Council Meeting

Tuesday 17 December 2024 at 6pm

4.1	Public Question Time	8
4.2	Petitions.....	8
4.3	Joint Letters	8
5	Officers' Reports.....	9
5.1	Waste to Energy Facility - 510 Summerhill Road, Wollert	9

5.2	Planning Scheme Amendment C269: Rezoning of 149 McKimmies Road, Bundoora: Planning Panel Outcomes and Adoption	46
5.3	Planning Scheme Amendments C286 and C287 - Heritage Overlay at 1470 Plenty Road, Mernda – Request for Authorisation and Interim Heritage Protection.....	202

Figure 2 Exhibited DPO40 Figure 1 (extract)

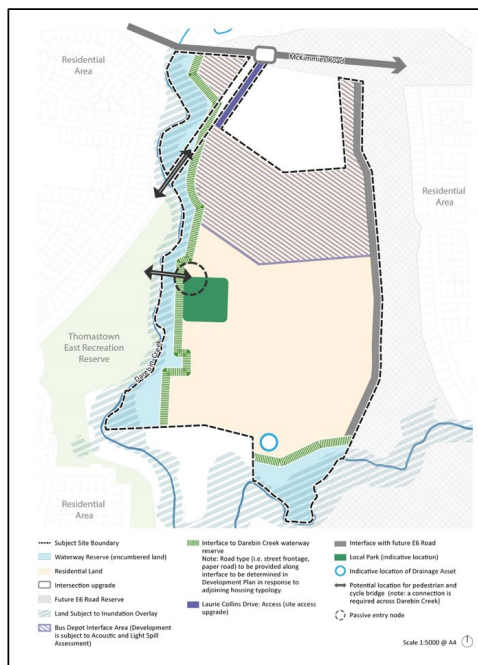
To give effect to that objective DPO40 Figure 1 nominated a ‘Top of bank 30m buffer zone’ along Darebin Creek and included a requirement at DPO40 Clause 4.0 to show a waterway corridor in an Open Space and Landscape Plan:

The Panel accepts the advice of agencies that a variable corridor is an acceptable outcome from a waterway and biodiversity perspective. This should be reflected in DPO40 Figure 1 and the Open Space and Landscape requirements in Clause 4.0.

The Panel agrees that the specific width of the waterway reserve needs to be informed by more detailed analysis of the site, biodiversity values, topography and final state of the site (including location of River Red Gums). Given the uncertainty about many of these aspects at this early stage of the process, DPO40 should adopt a precautionary approach by showing a wider indicative waterway reserve in Figure 1.

- a) **more clearly explain in Clause 4.0 the matters that needs to be considered when determining the final width of the waterway reserve**
- b) **show in Figure 1, a wider waterway reserve (particularly in the south-western part of the subject land).**

Figure 3 Interface treatments recommended by Mr Leo

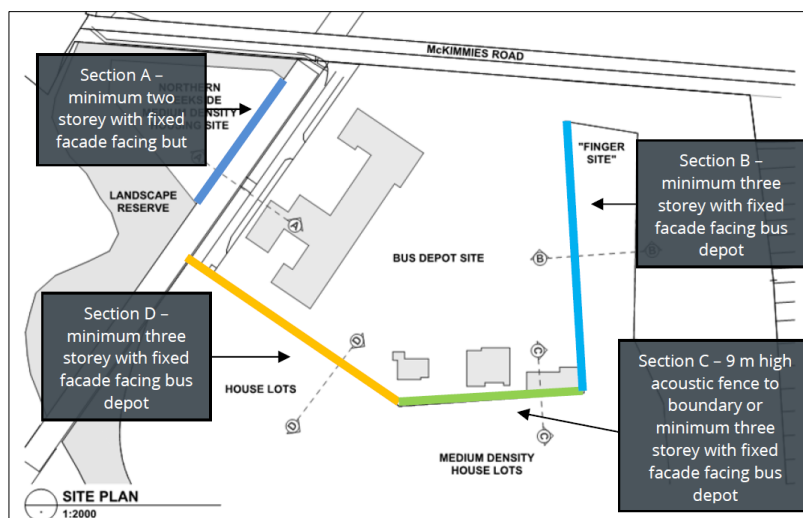
Mr Leo's evidence recommended treatment options along interfaces to the bus depot, as summarised graphically in Figure 3.

Figure 1: Framework Plan

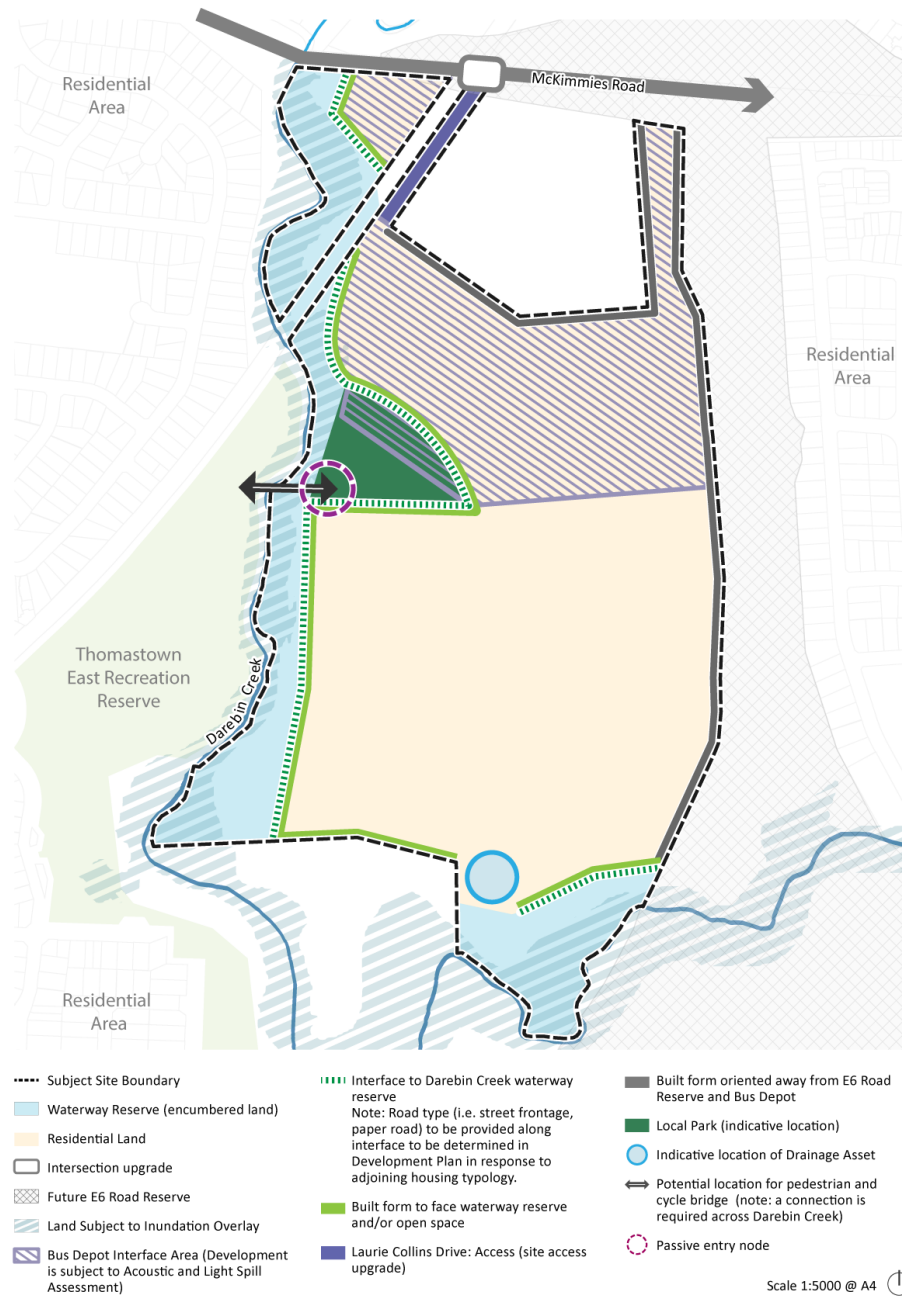
NOTE: TRACK CHANGES ARE OFFICER RECOMMENDED CHANGES TO THE DPO VERSION CONTAINED IN THE PANEL REPORT

Figure 1: Framework Plan

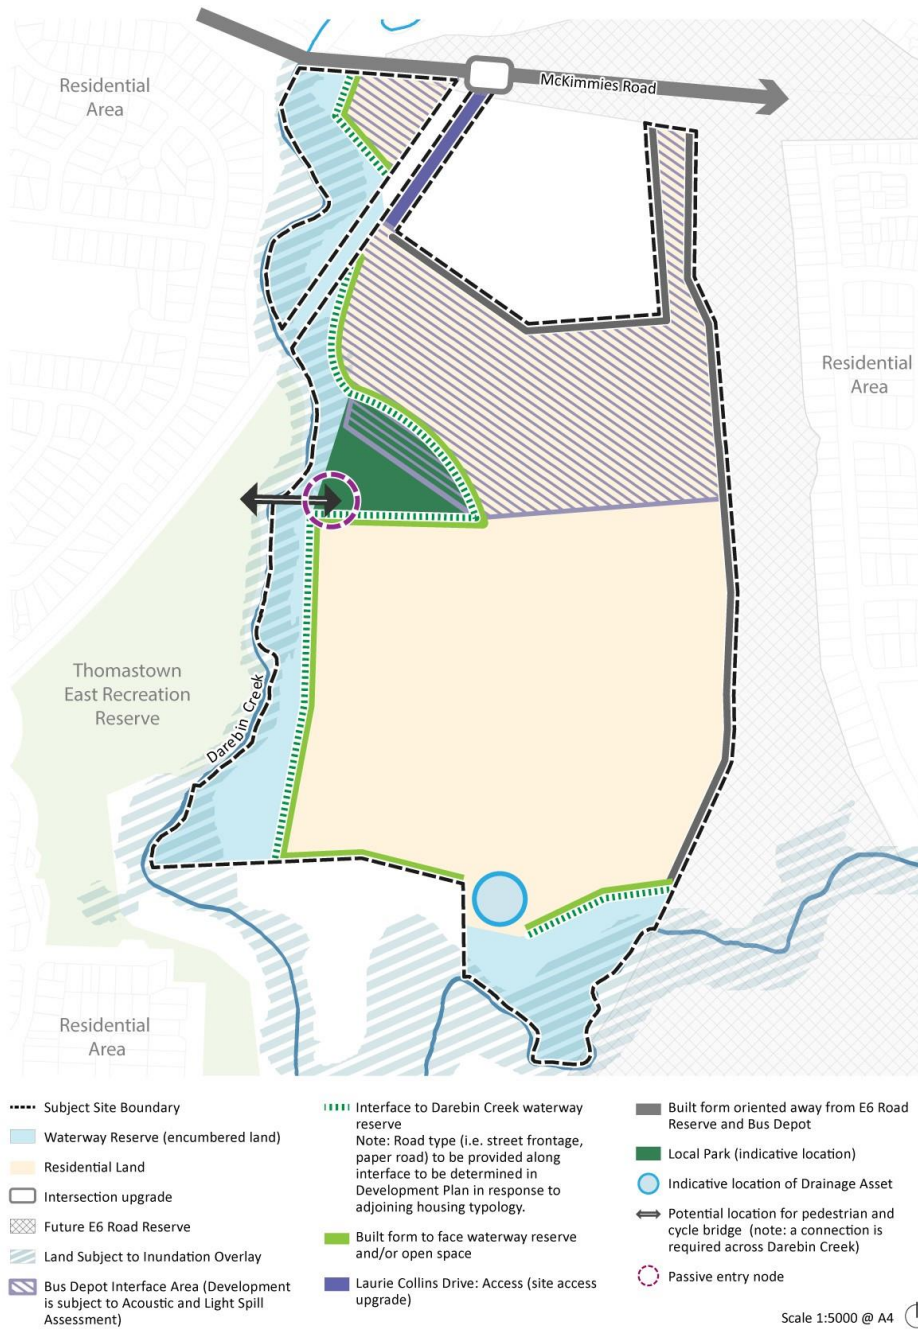
o) Show a wider waterway reserve (particularly in the south-western part of the subject land)	Supported. Panel recommended Framework plan at Figure 1 is adopted.

p) Reflect the wider waterway reserve width (particularly in the south-western part of the subject land) with a more generic line around the River Red Gums	Supported. Panel recommended Framework plan at Figure 1 is adopted.
